**XEROX BUILDING 801
HENRIETTA, NEW YORK**

**REMEDIAL INVESTIGATION AND FEASIBILITY STUDY
WORK PLAN
ADDENDUM**

MAY 15 1992

App. A, Sec. 2, Figure 2.1

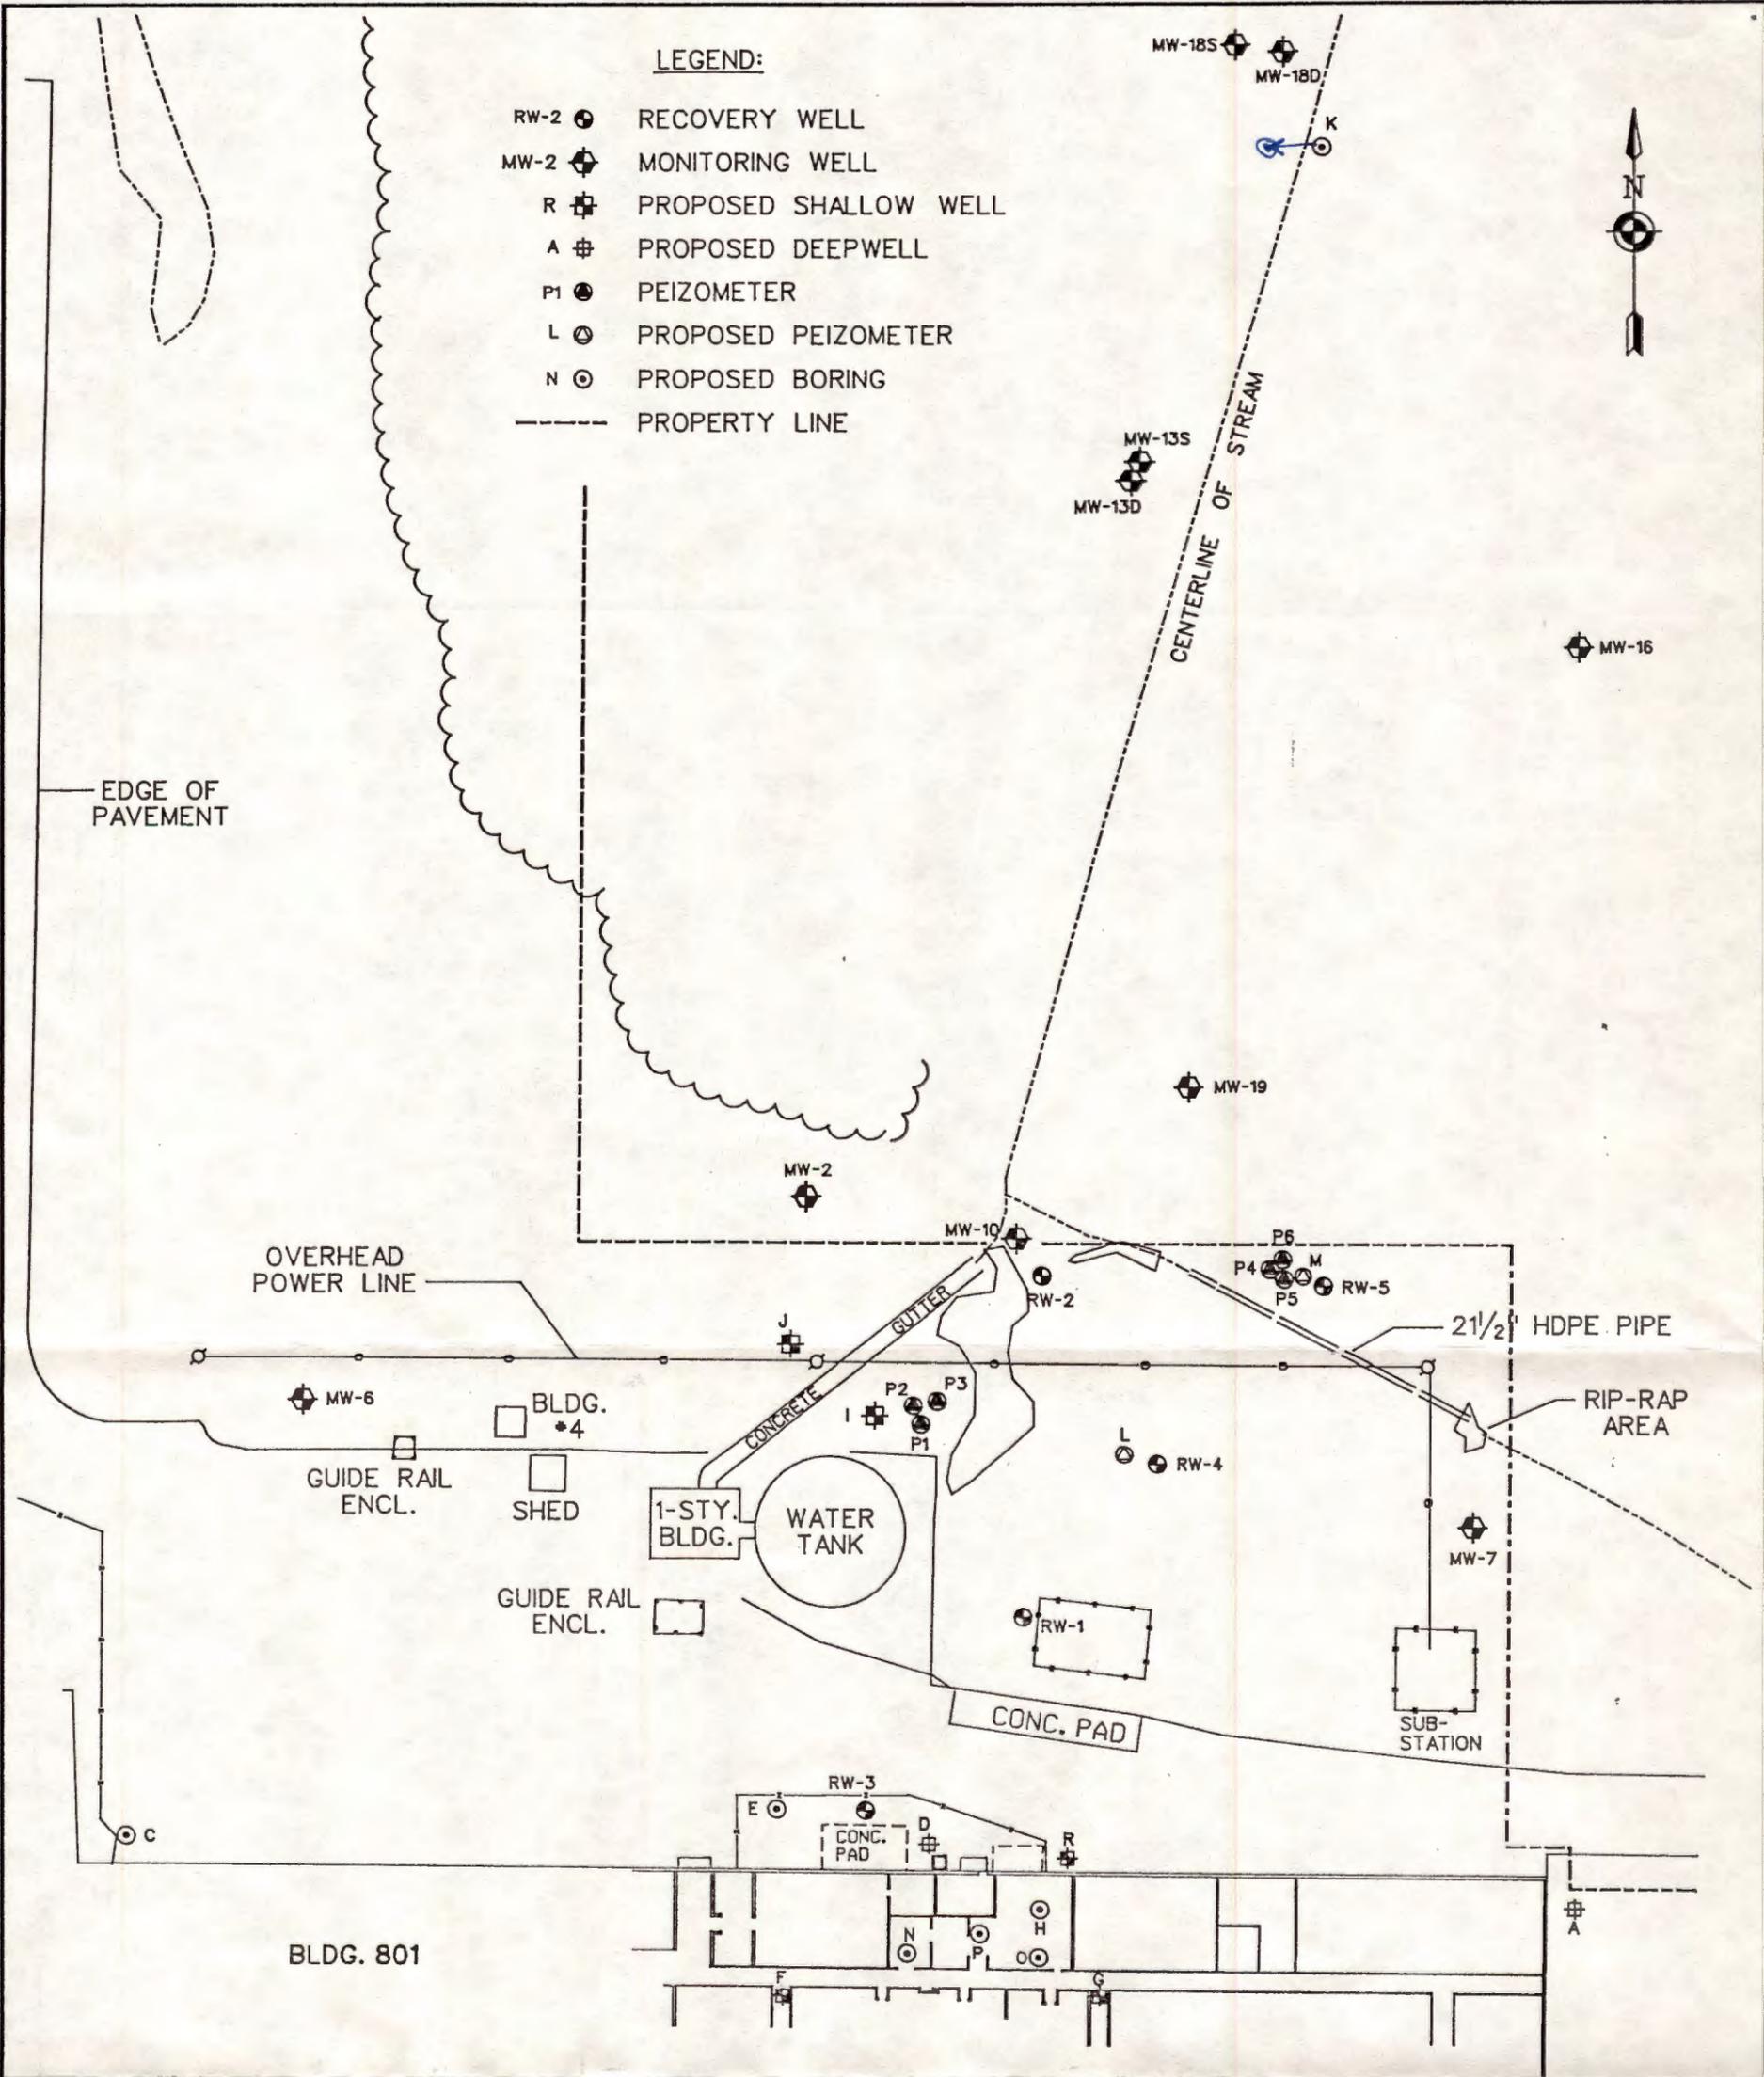
It should be noted that in this work plan letters have been used to temporarily identify individual boring locations. The locations are shown on Figures 2.1 and 2.2. Upon completion, each boring or monitoring well will be assigned a sequential number based upon the order in which it was completed. This is intended to eliminate possible confusion if modification or expansion of either phase of the program is necessary.

Deep borings (i.e. those drilled through the clay confining layer) located in the source area would require the use of non-conventional drilling techniques. At present only one boring (D on Figure 2.1) of this type is proposed. To complete this boring conventional hollow stem auger and split spoon sampling techniques will be utilized above the confining clay layer. This drilling will be performed using 6-1/2-inch I.D. augers. When the clay layer is reached, the augers will be carefully withdrawn to minimize caving. A 9-inch diameter steel casing will then be set in the clay and the annulus grouted using cement/bentonite grout. When the grout has set, 4-1/4-inch hollow stem augers will be used to continue drilling through the center of the steel casing. The boring will be continued to the bedrock interface, an anticipated depth of approximately 40 feet. A 2-inch I.D., deep observation well will then be installed in accordance with the methodology described in the following section. Based on the drilling conditions encountered, it may be necessary to complete the lower portion of the boring using 2-1/2-inch I.D. augers. This would require a reduction in the well diameter to 1.0 inches.

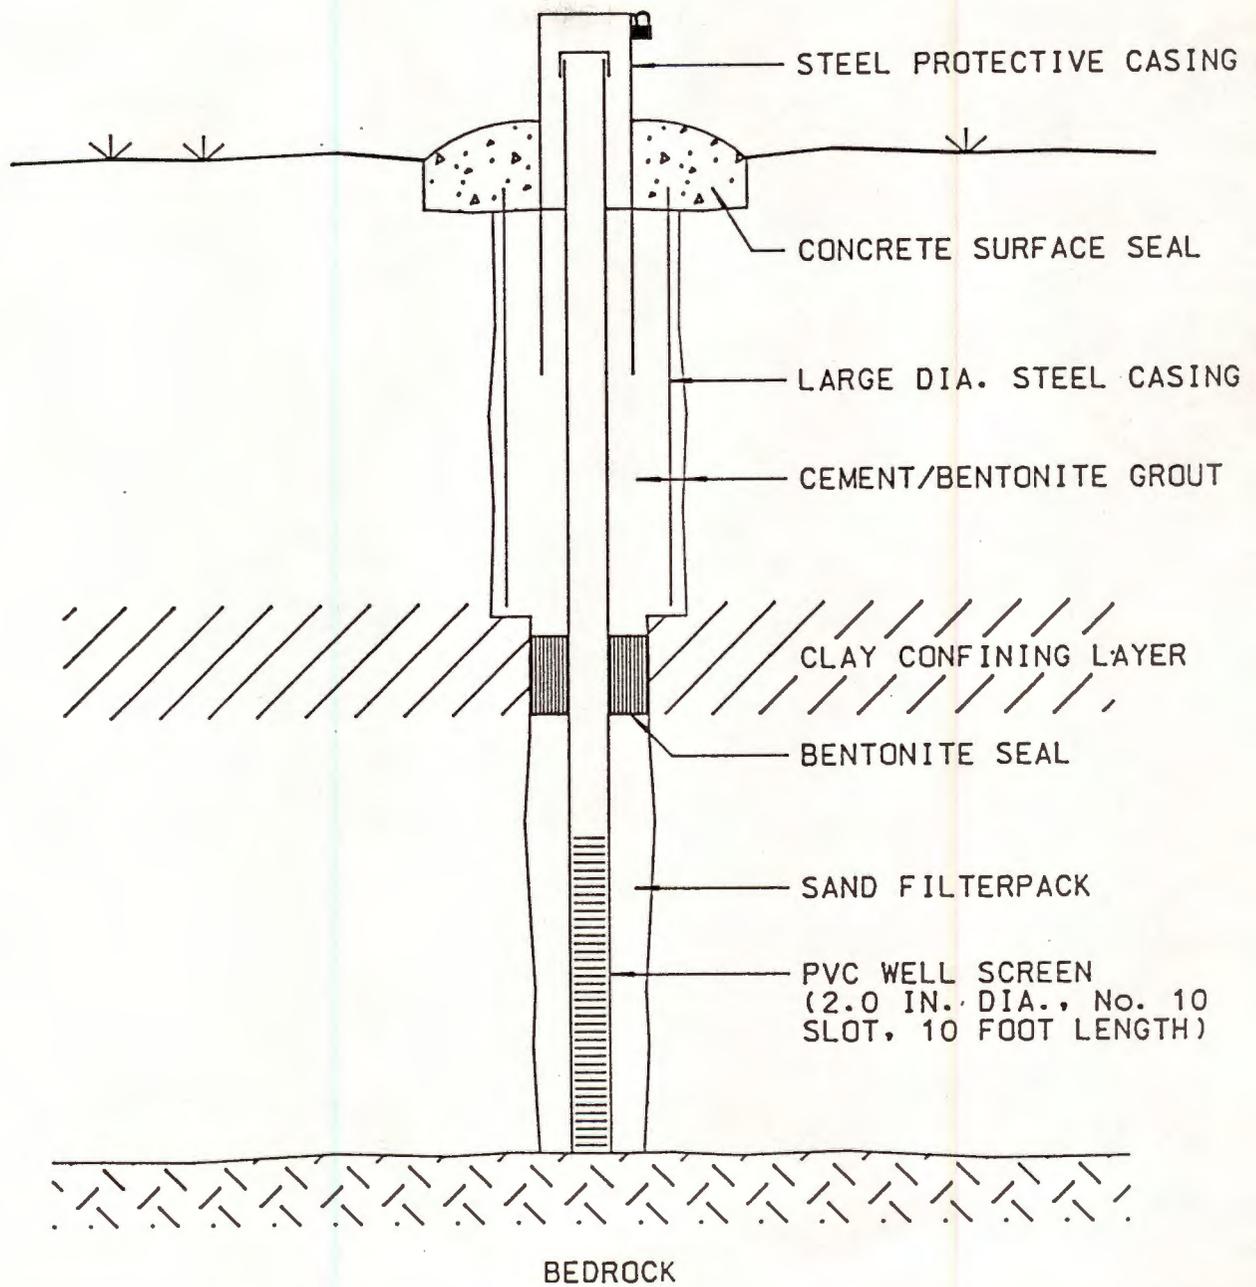
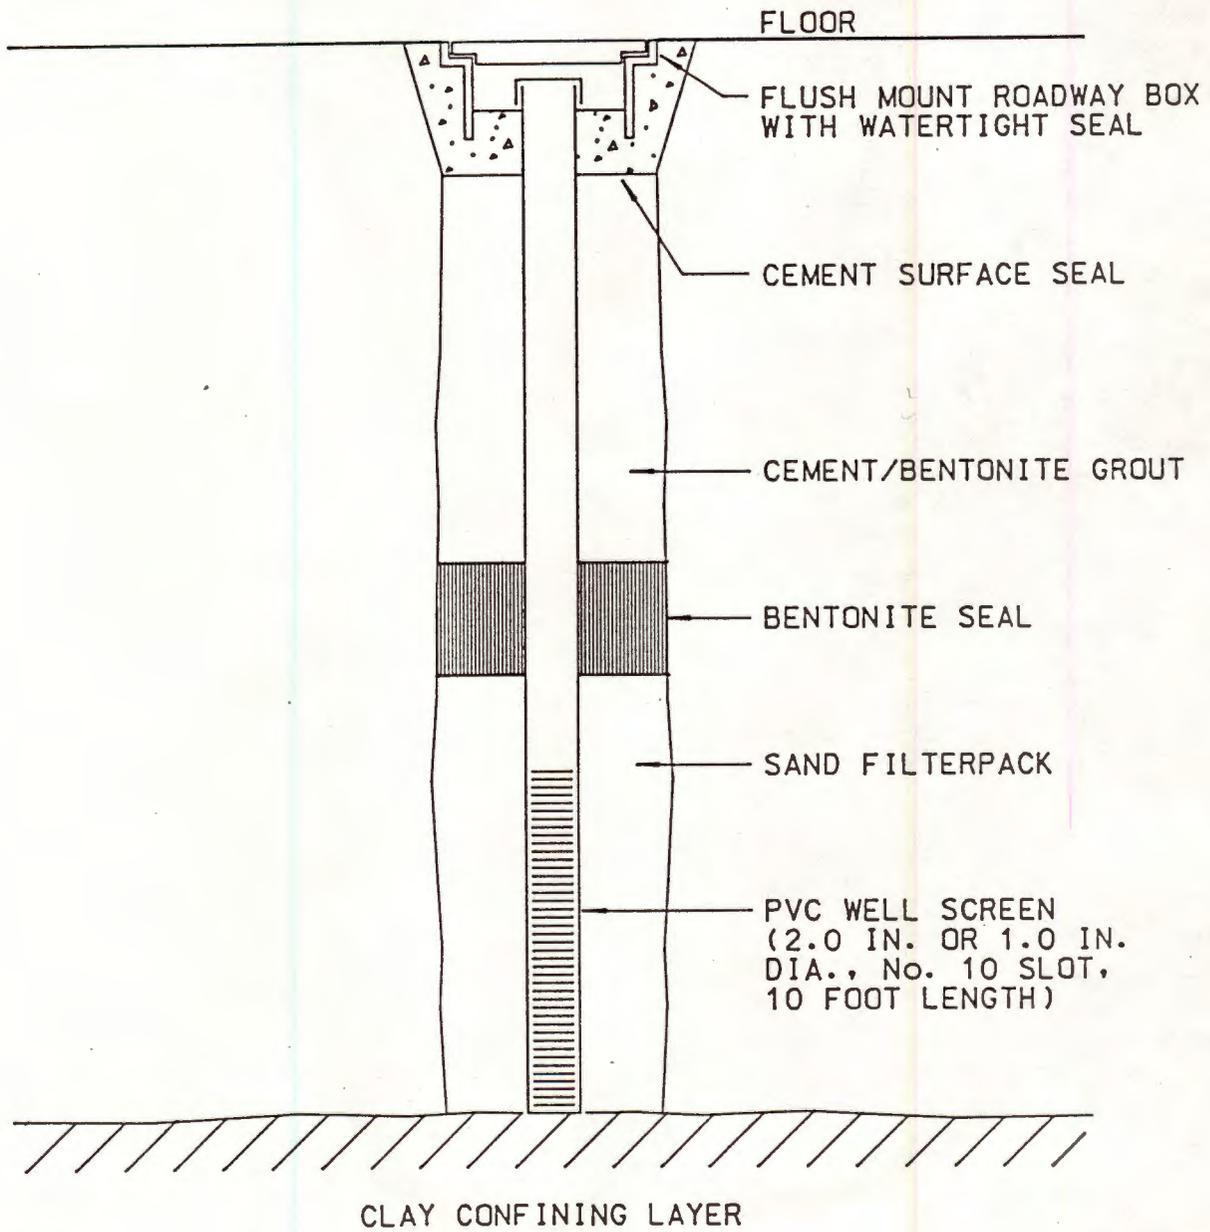
Deep wells proposed for the site include one (1) pumping well and five (5) observation wells. The pumping well will be constructed using approximately 10 feet of 4-inch diameter No. 10, continuous slot, PVC screen and the appropriate length of riser. The observation wells will be constructed using 10 feet of 2-inch diameter, No. 10 machine slot PVC screen and riser. All deep wells will be set with the bottom at the bedrock interface, a depth of approximately 40 feet. A sand pack of appropriate grain size and composition will be used to fill the well annulus up to approximately the base of the confining clay layer. A bentonite seal, no less than 3 feet thick, will be placed above the sand pack to ensure that the well is sealed within the clay layer. The remainder of the annulus will be backfilled with bentonite/cement grout and well will be appropriately finished and protected at the surface. Proposed deep pumping and deep observation well construction details are illustrated in Figures 3.1 and 3.2.
